## HIROSE ELECTRIC CO., LTD.

# Notice of FH28 Series Actuator Design Change

FH28 Series, 40 contacts (5 products)

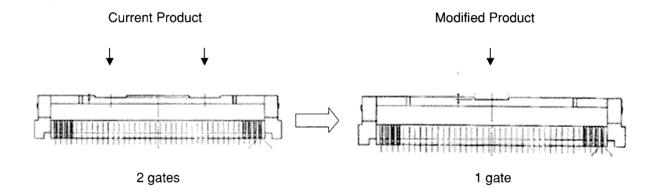
The actuator's 2 gates will be changed to 1 gate. The appearance will change as illustrated in the diagrams below.
